Power4Flight Product Advisory

B100i Throttle Linkage - Inspection and Update Procedures

Date: 7/15/2021

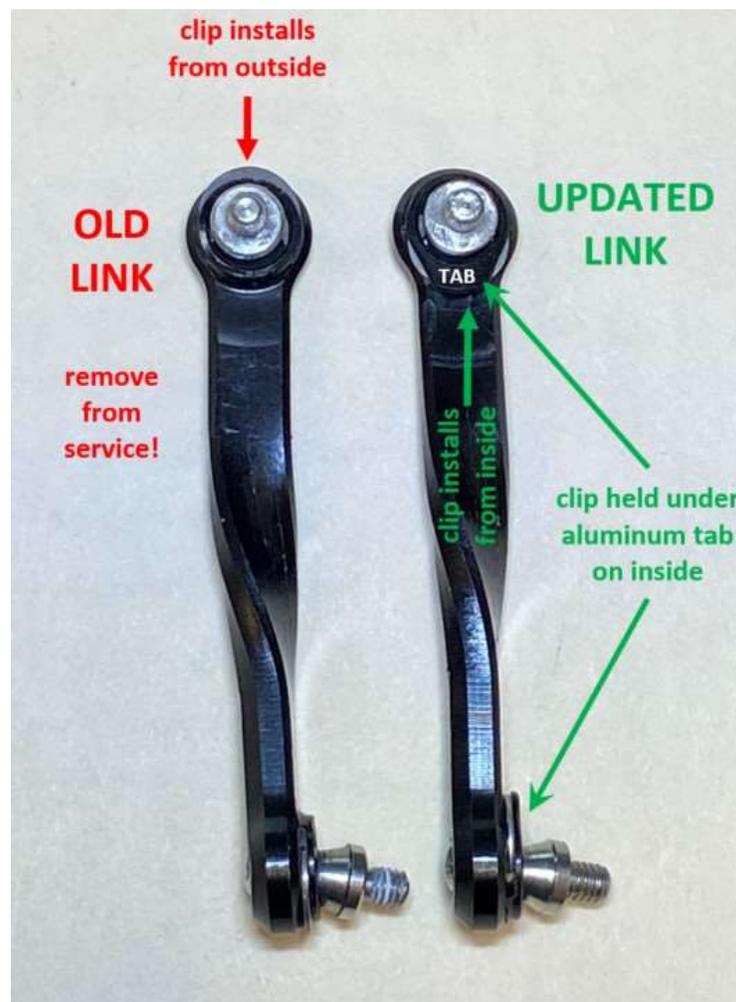
The new linkages, that were deployed after the first incident, hold the clip from the inside of the arm which limits the potential clip movement and to date seem to show less wear. We have had no failures with the new-style (current) arm. There is always room for improvement, so we are looking at further mitigation measures on the current arms that we plan to roll out once properly tested and validated. Until then we recommend that:

The first step for all B100i engine customers is to identify which linkage configuration you have installed on each engine. The diagram below shows the two versions side by side – the old-style is shown on the left and the current version is on the right. If you have an old-style linkage installed, we recommend that you contact Power4Flight so we can get you a replacement linkage assembly. **We do not recommend flying the old-style linkages given we have seen a second failure.**

1. Any engine with the old-style linkage be identified, inspected and grounded.
2. All old-style arms be removed and replaced with the current version before being returned to flight.
3. All engines with the current version of the linkage be inspected before returning to flight.
